REPORT TO DEVELOPMENT MANAGEMENT COMMITTEE 10 April 2024

REFERENCE: HW/FUL/23/00488

- **APPLICANT:** Harlow District Council C/O McBains
- **LOCATION:** Land to the West of Harlow Playhouse, College Gate, Harlow
- **PROPOSAL:** Redevelopment of land to the west of Harlow Playhouse, including Occasio House, to provide a 2 no. storey detached extension to Harlow Playhouse to provide creative studios and performing arts space, music school and recording studio, cafe, changing rooms and booking office (Sui Generis); and an additional part 6 no. and part 5 no. storey building to provide flexible commercial and community floorspace at ground floor level (Use Class E and Use Class F.1/F.2) with residential flats above (Use Class C); together with landscaping, public realm improvements, improvement works to the Haydens Road subway, re-direction of College Gate and re-location of the taxi rank; and associated access and parking provision.

Figure 1 - Townscape Viewpoints

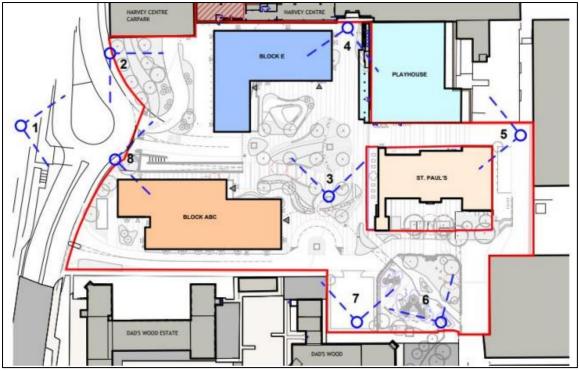
They do, however, note that the proposed development would result in a degree of less than substantial harm due to the loss of a significant view of the church from Hayden's Road (viewpoint 2 as shown in Figure 1). In such circumstances, this triggers the requirements of NPPF Paragraph 208 whereby a proposal which is considered to lead to less than substantial harm to the significance of a designated heritage asset must be weighed against the public benefits of the proposal.

Nevertheless, Places Services acknowledge that the design of Block E has been revised to introduce a glazed corner and curtain wall at ground floor which contributes to a more visually permeable and lightweight appearance making it generally less prominent in views towards the church. This reduction in view must also be tempered by the retention of a central open view towards the church (viewpoint 1) to reinstate its role as a focal point and landmark site as part of the redevelopment of the area. This is considered to better frame the church (see Figure 2).
